*City of Portsmouth
Public Works Department*

**Addendum #1
Parrott Ave Parking Lot Project
Bid Proposal #14-16**

Issued September 17, 2015

This addendum forms part of the original document marked: **Bid Proposal #14-16 – Parrott Ave Parking Lot Paving**. Please acknowledge this addendum within your proposal, failure to do so may subject a bidder to disqualification. Failure to acknowledge receipt of the Addendum may subject the Bidder to disqualification.

CONSTRUCTION PLAN
FOR
PARROTT AVE PARKING LOT
SITE IMPROVEMENTS
PORTSMOUTH, NEW HAMPSHIRE
AUGUST 2015

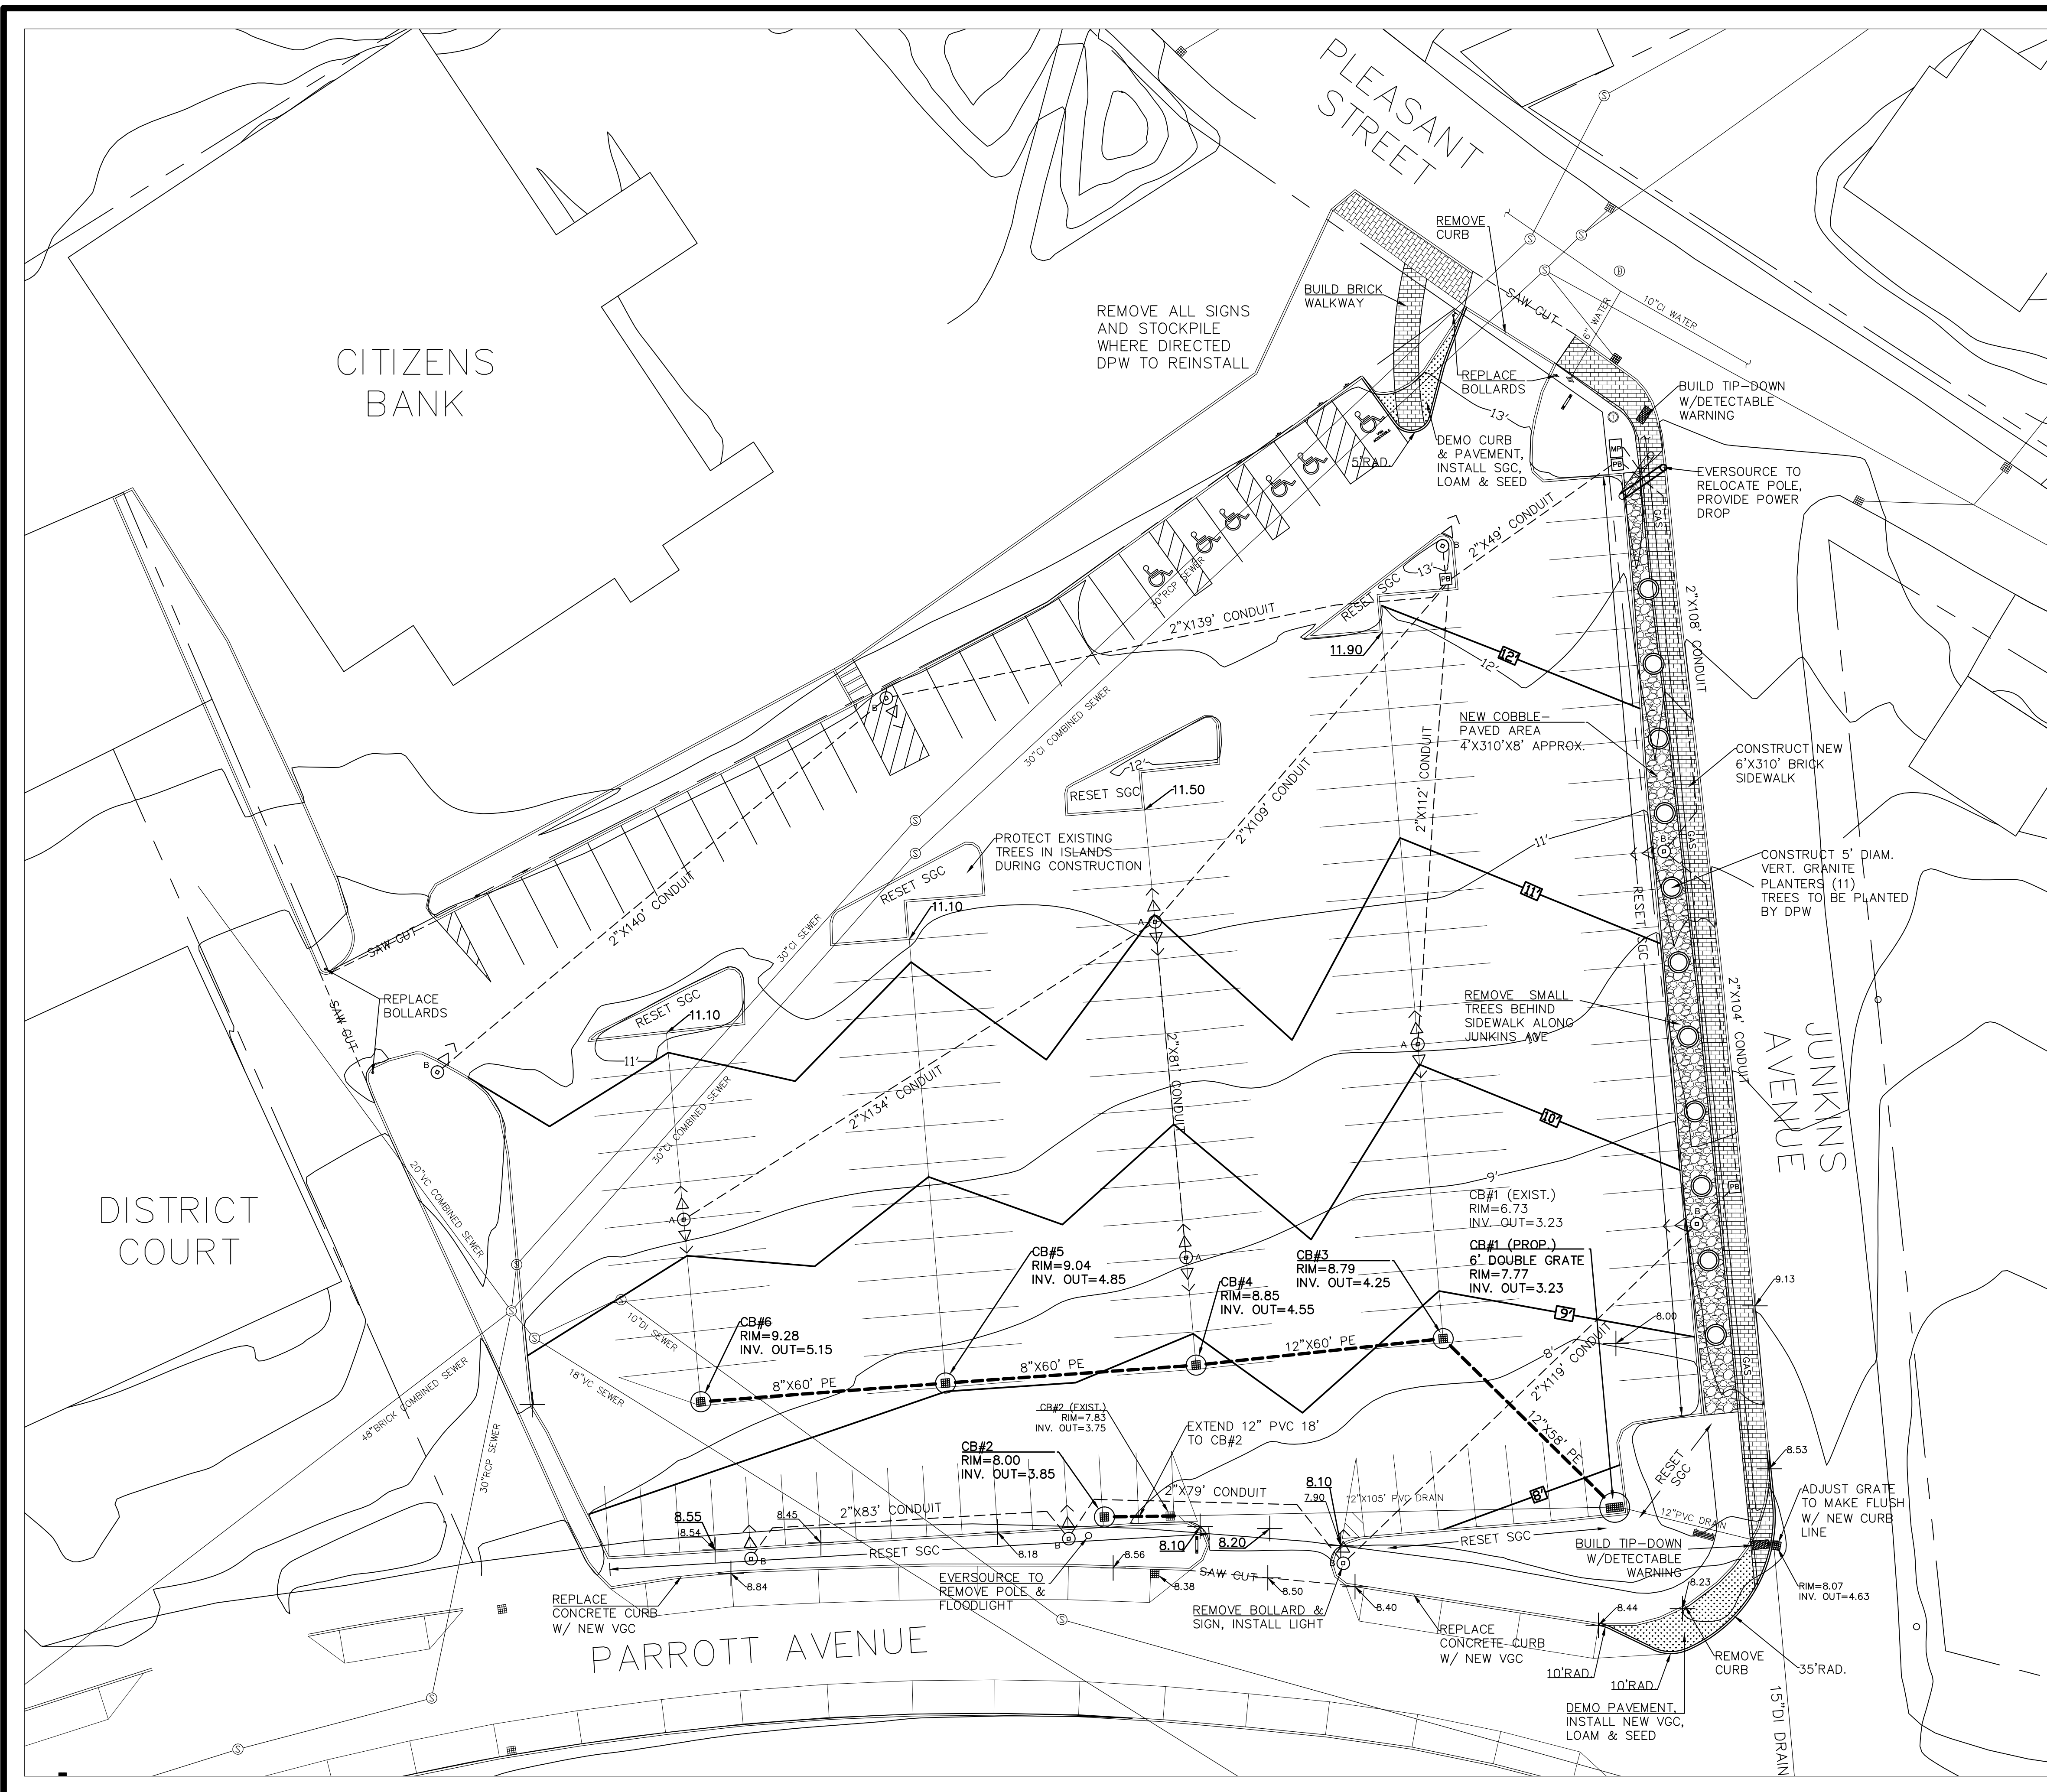
Item 1-7 Site Plan

The Citizens Bank property line has been adjusted to align with the curb line on the northern side of the parking lot. The light pole near the stairs has been relocated accordingly.

One additional style 'A' light has been added in the parking field and conduit runs have been adjusted accordingly. One (1) pull box has been added.
